**July 17, 2024**

### **COYOTE BOOSTER PUMP STATION PUMP CAN REPLACEMENT PROJECT NO. 53002**

#### **ADDENDUM NO. 1**

**WATER IMPROVEMENTS**  
**COYOTE BOOSTER PUMP STATION PUMP CAN REPLACEMENT**  
 SITE AND DEMOLITION PLAN

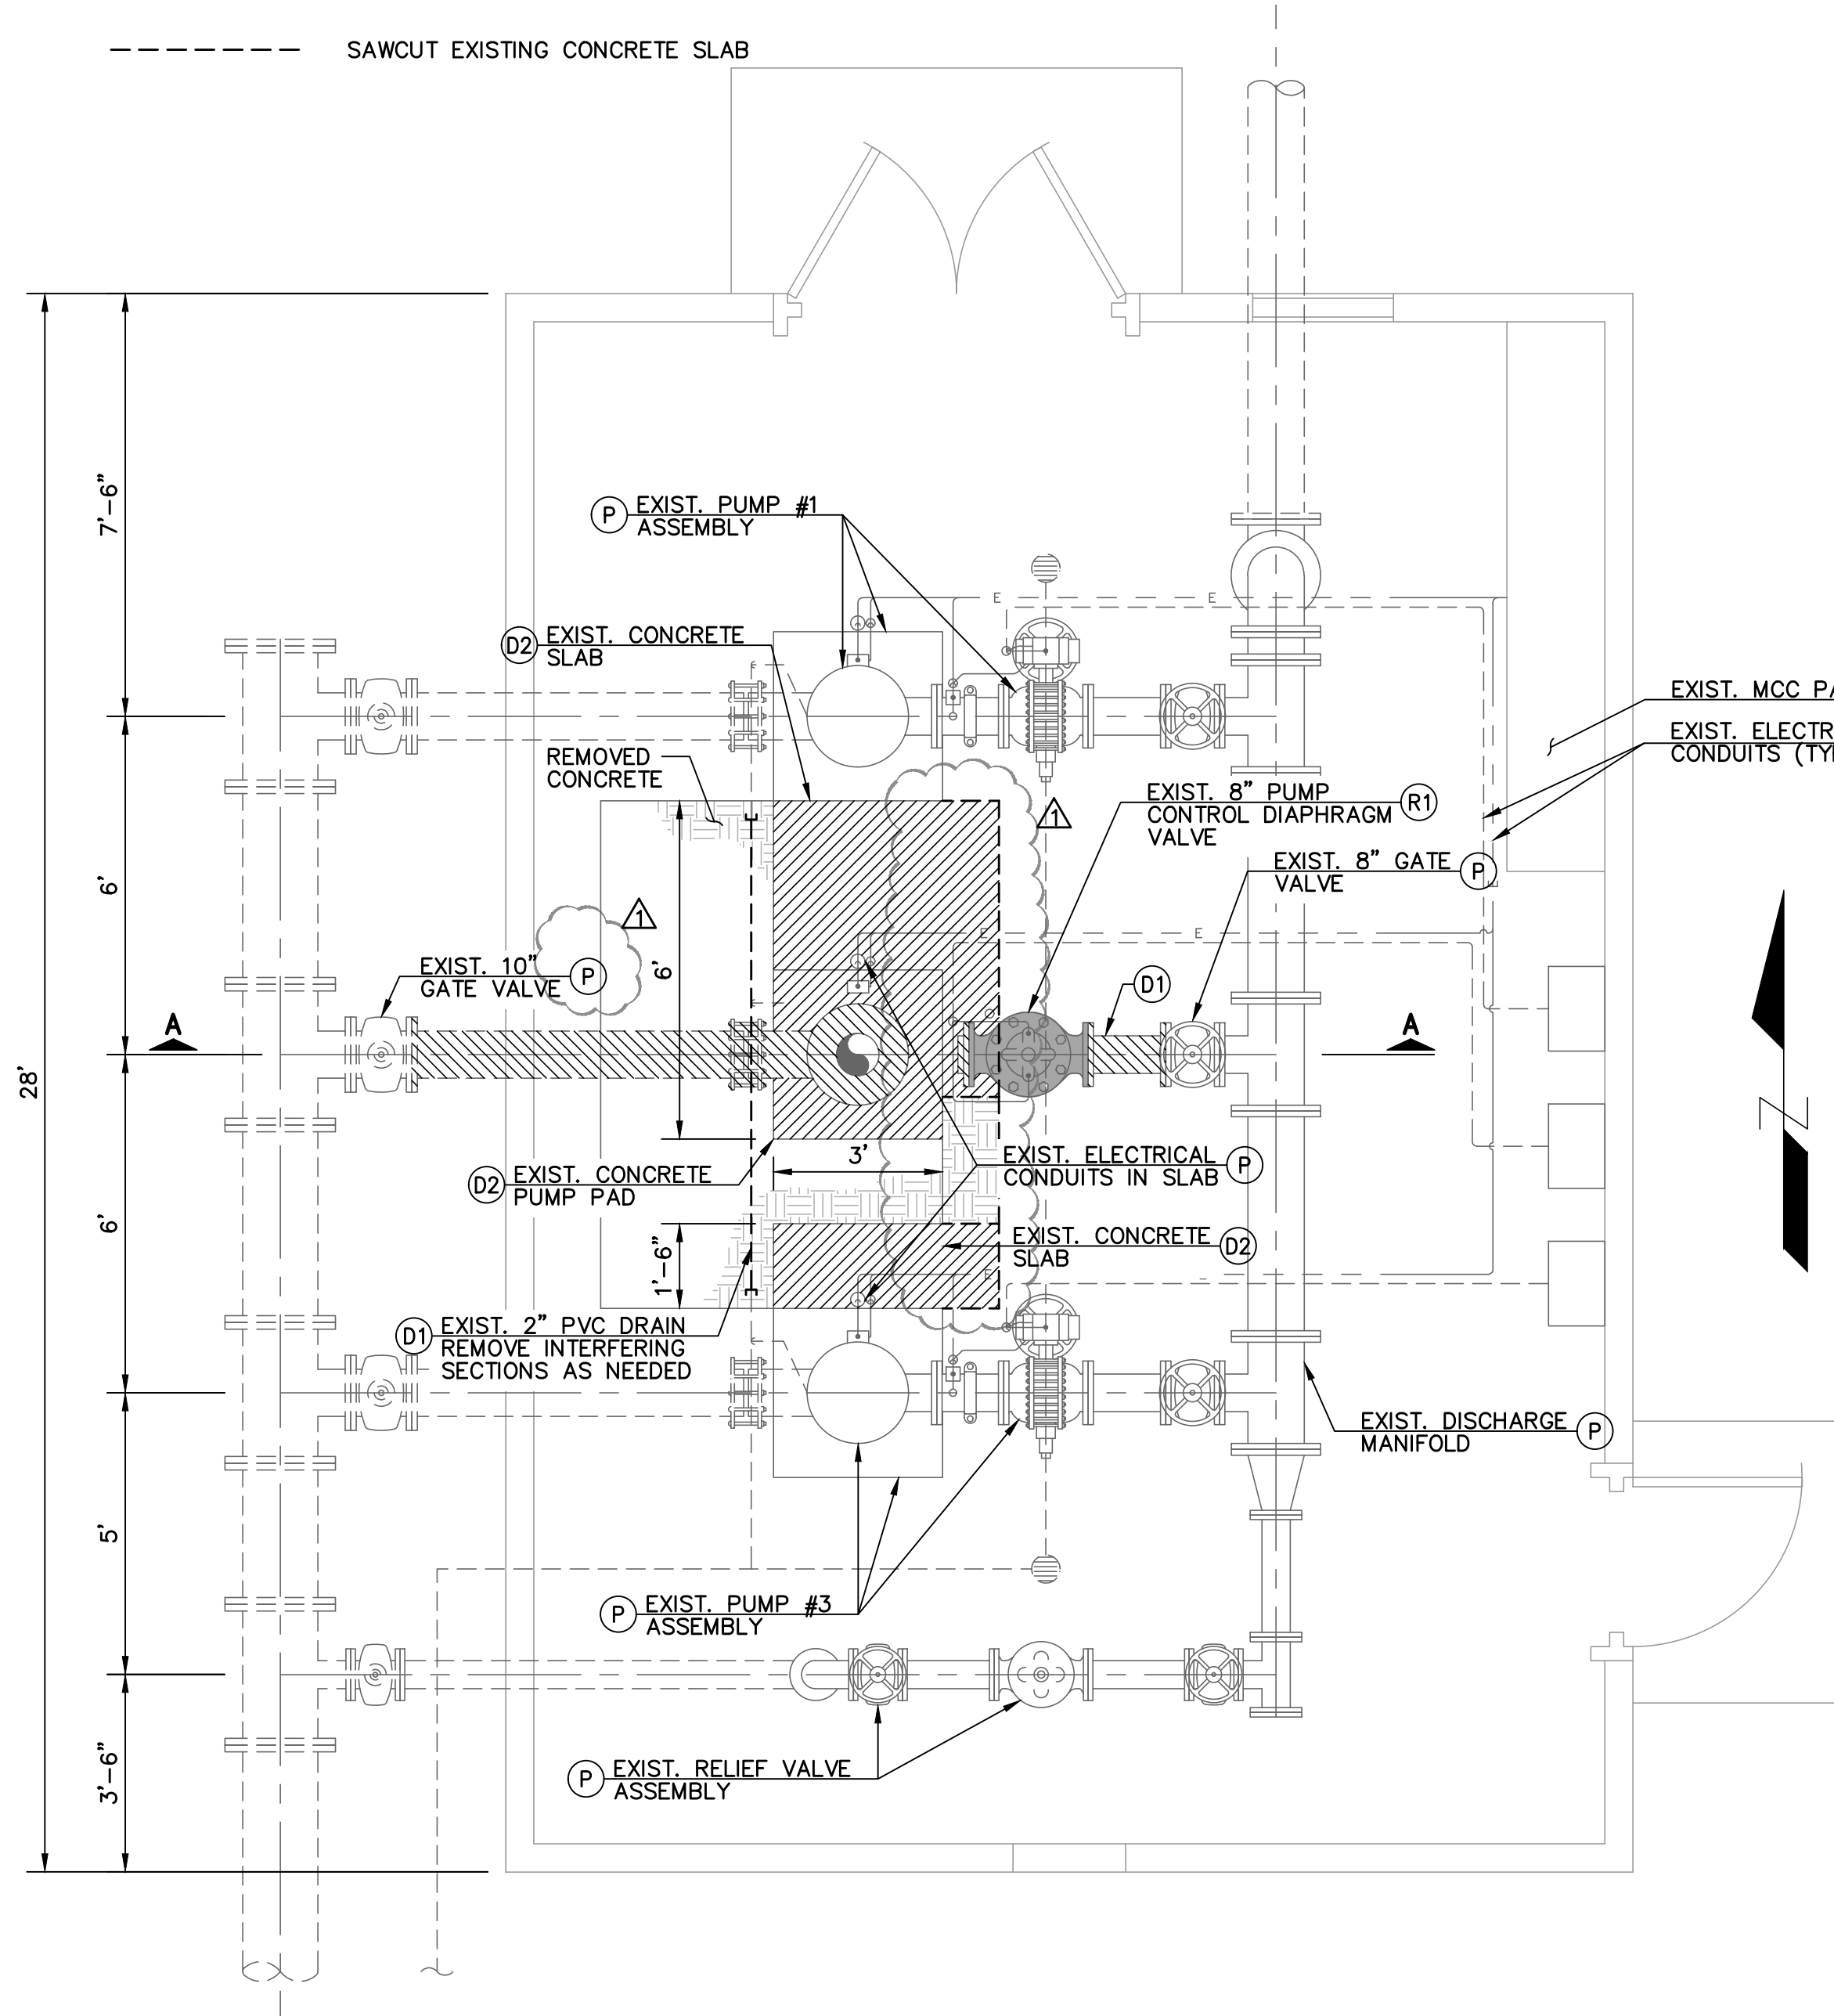
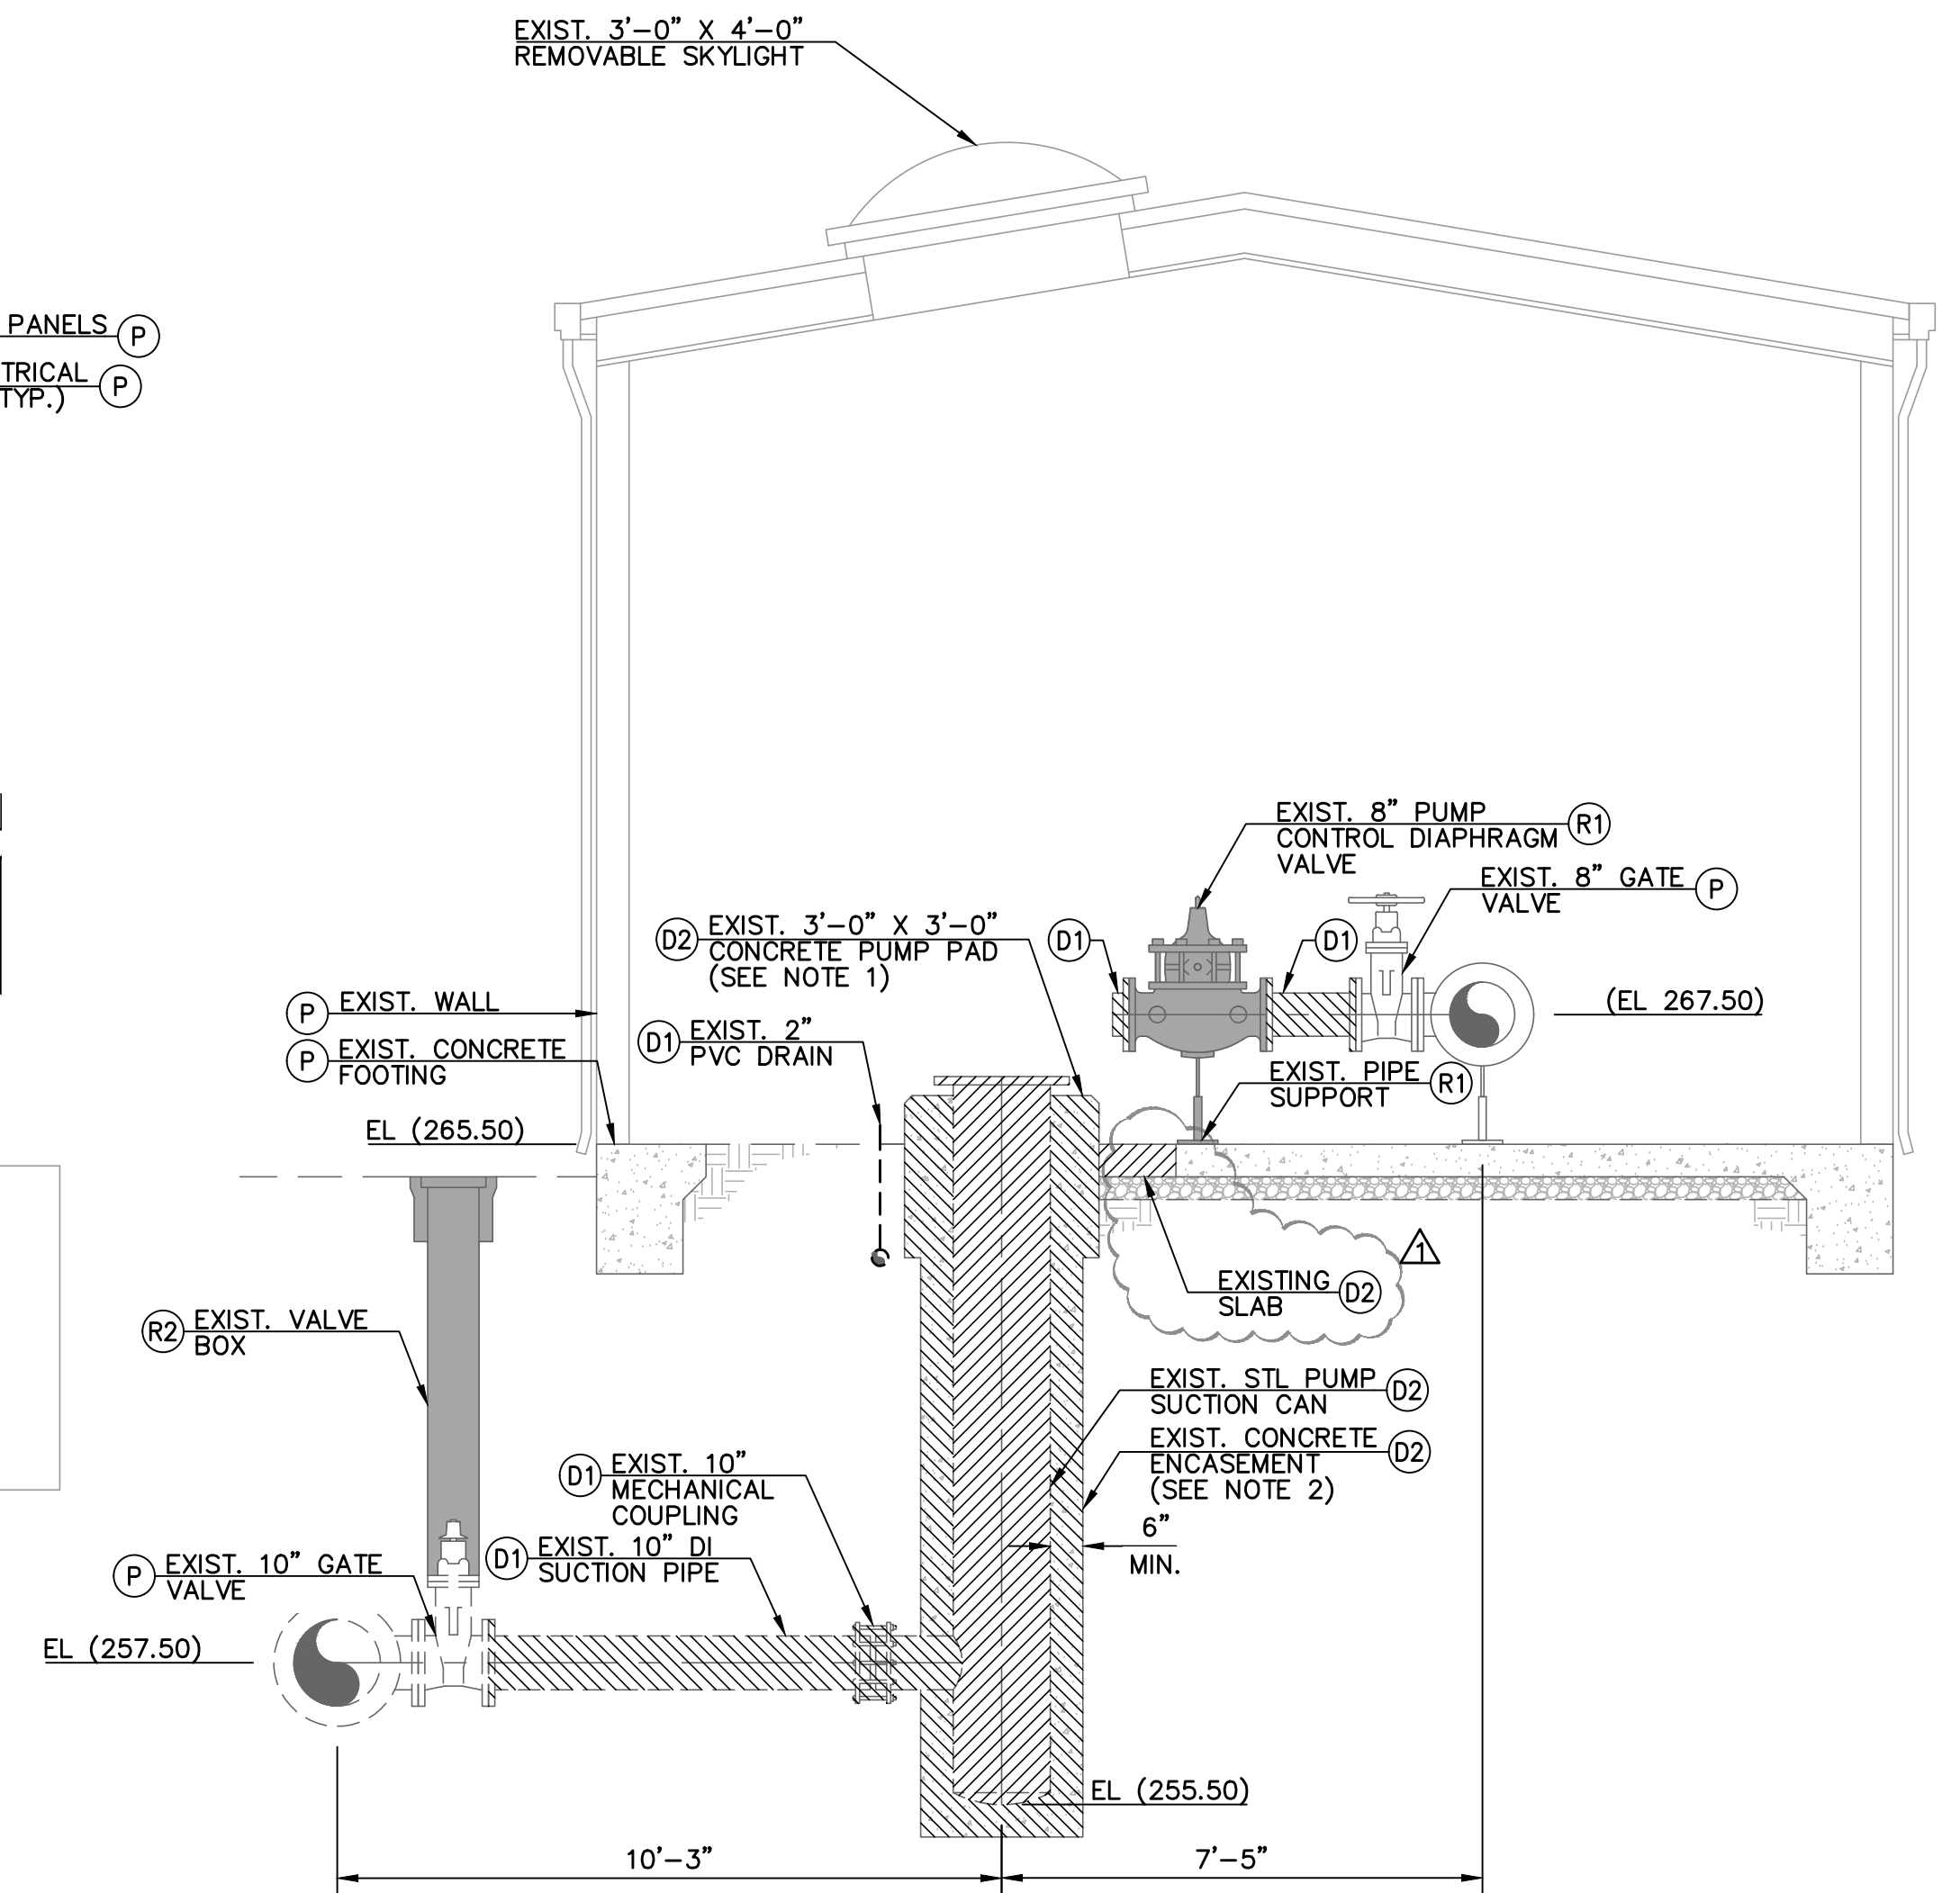
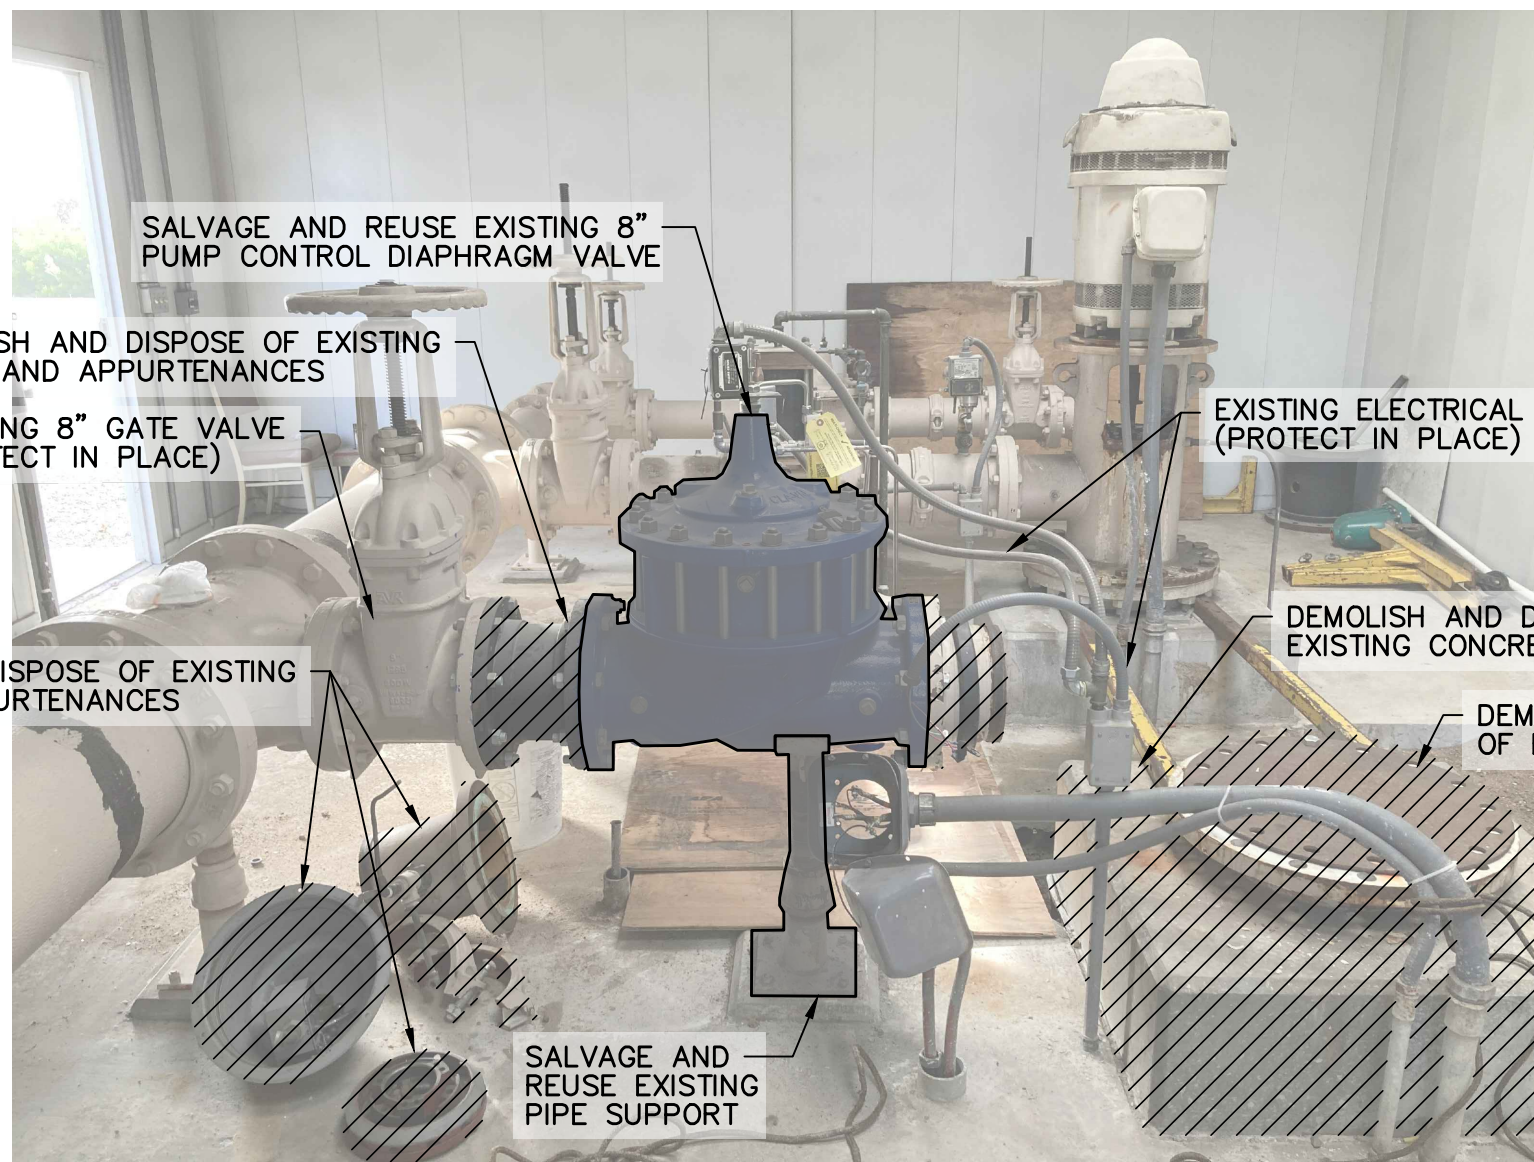
**Sheet 2 of 4 – Site and Demolition Plan**

REMOVE and REPLACE with revised Sheet 2 of 4 (attached).

- NOTE:**
1. CONTRACTOR TO DEMOLISH EXISTING CONCRETE PUMP PAD PRIOR TO REMOVING CONCRETE ENCASED PUMP CAN THROUGH OPENING OF EXISTING SKYLIGHT.
  2. CONCRETE ENCASEMENT MAY NEED TO BE JACK HAMMERED TO SIZE TO REMOVE PUMP CAN THROUGH EXISTING OPENING.
